# Appeal for Moderation: 7009 Shirley Drive

# Build To Enhance the Neighborhood, Not Divide and Impose Unnecessary Risk

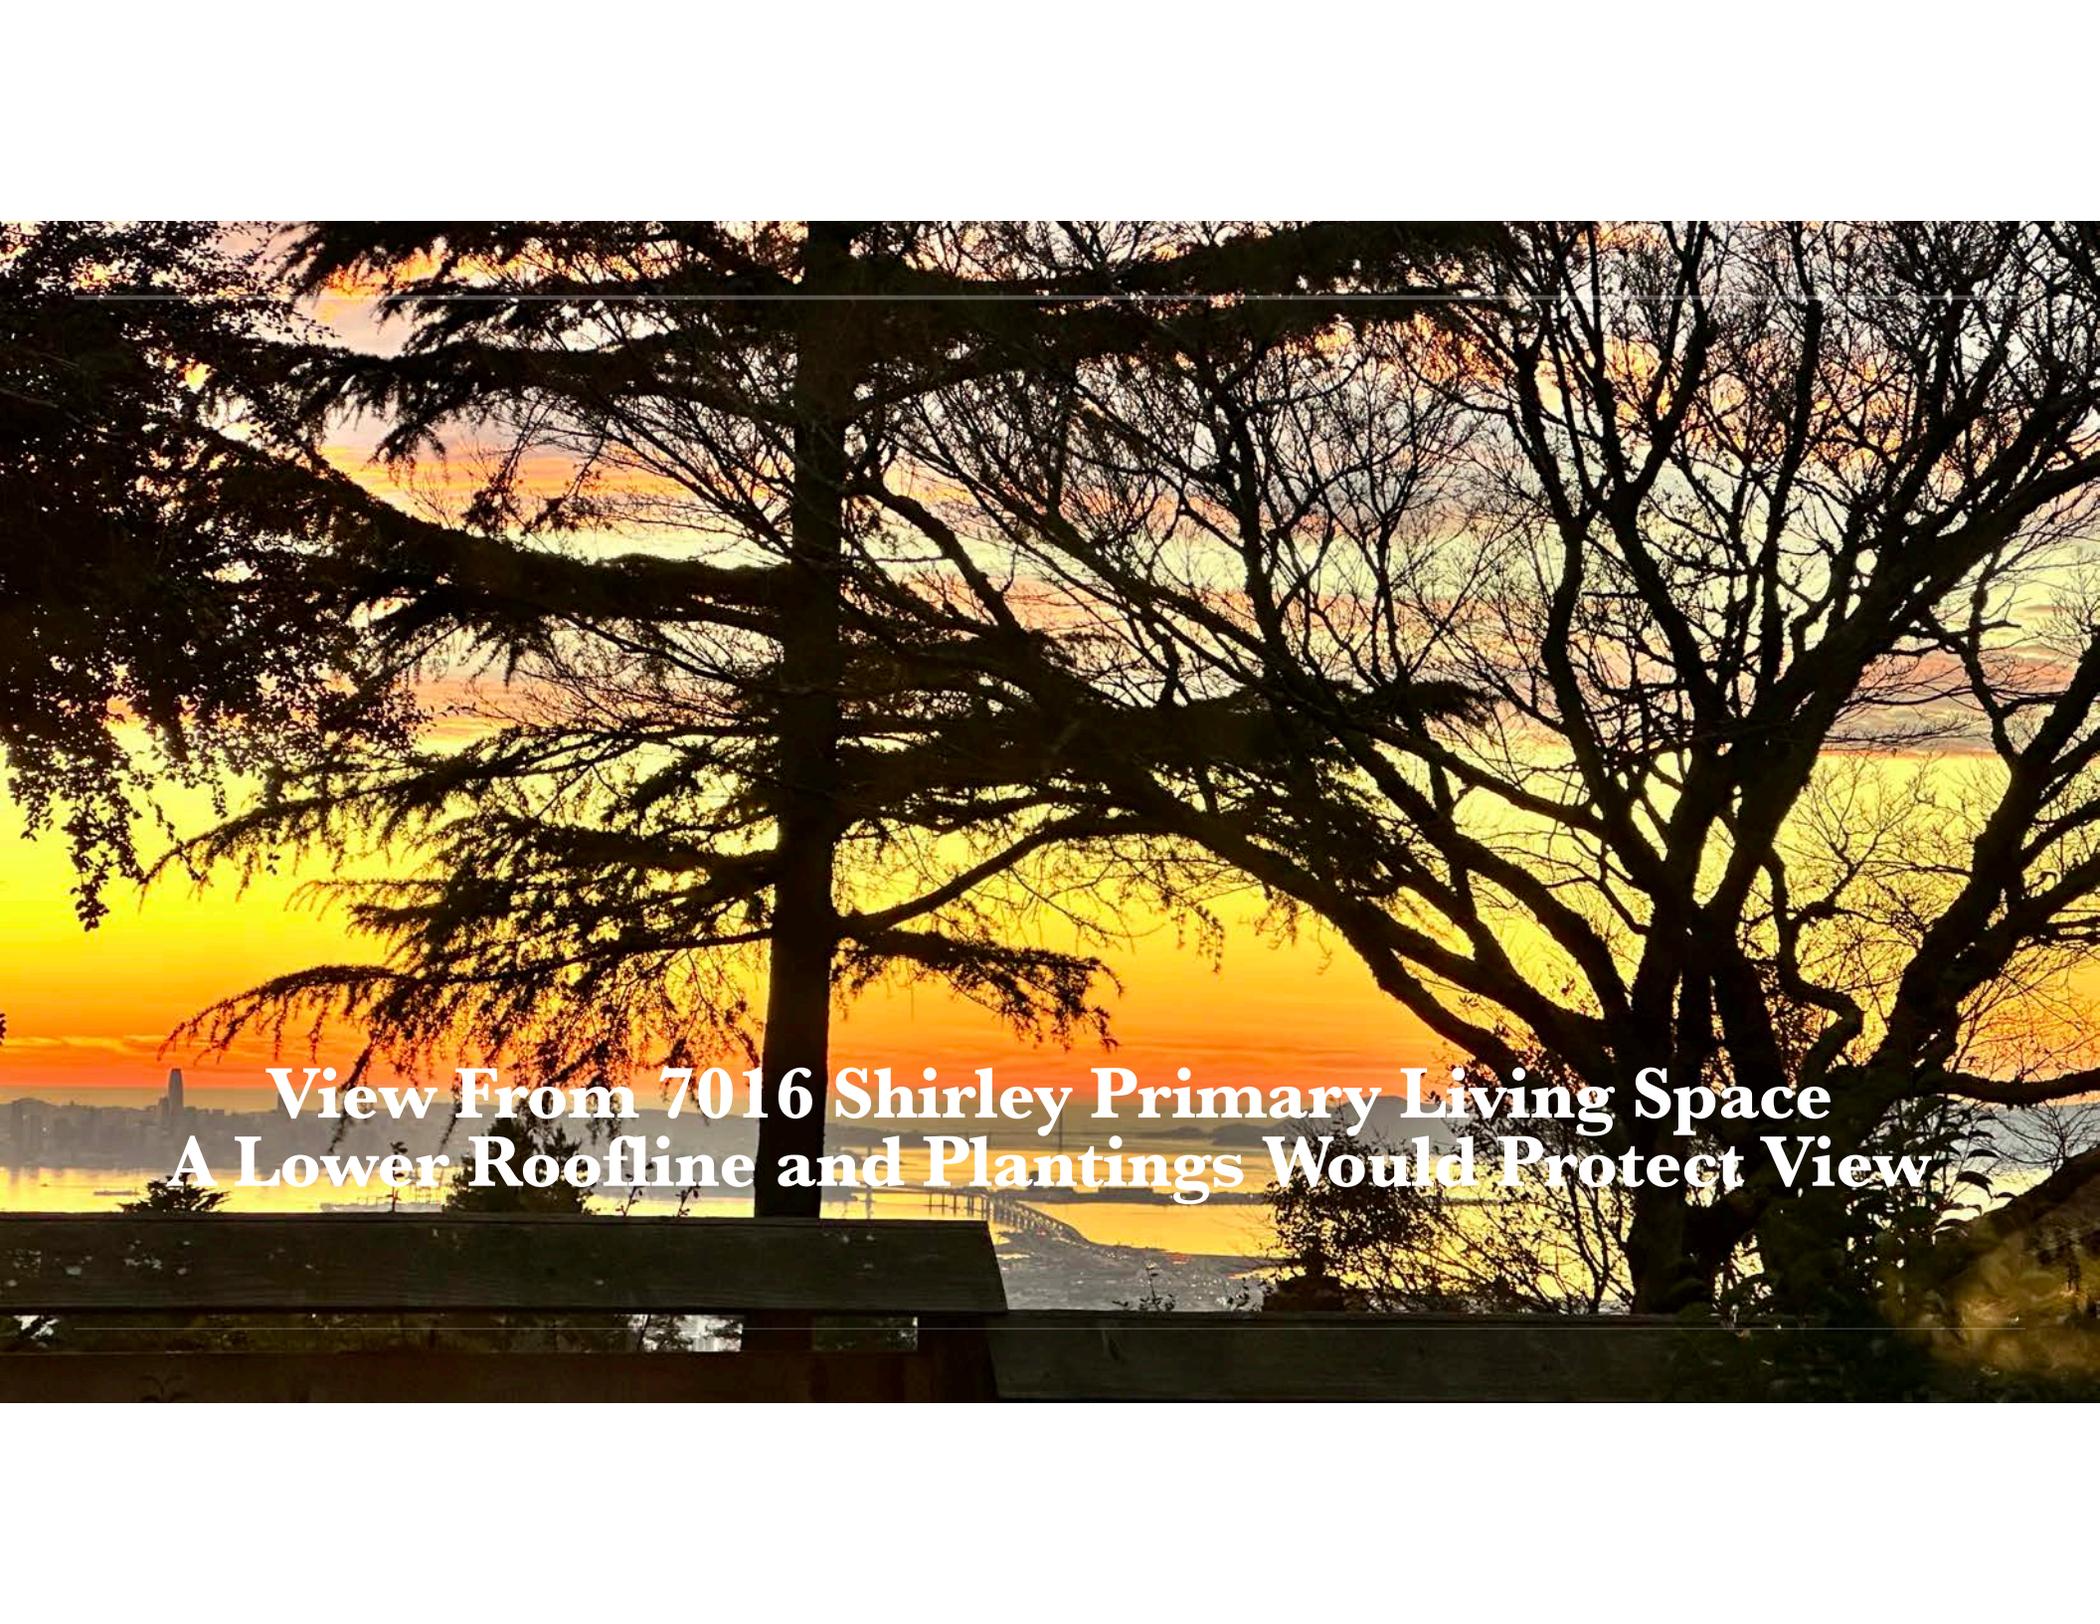
**Applicant chose non-native, view-blocking, flammable trees for their site design, counter to good sense and Oakland's codes and ordinances on choosing trees, particularly in the VHFHSZ.**

**This is an easy fix, since landscaping comes much later in the build process.** The Board can easily direct Applicant to choose trees that don't block our view.
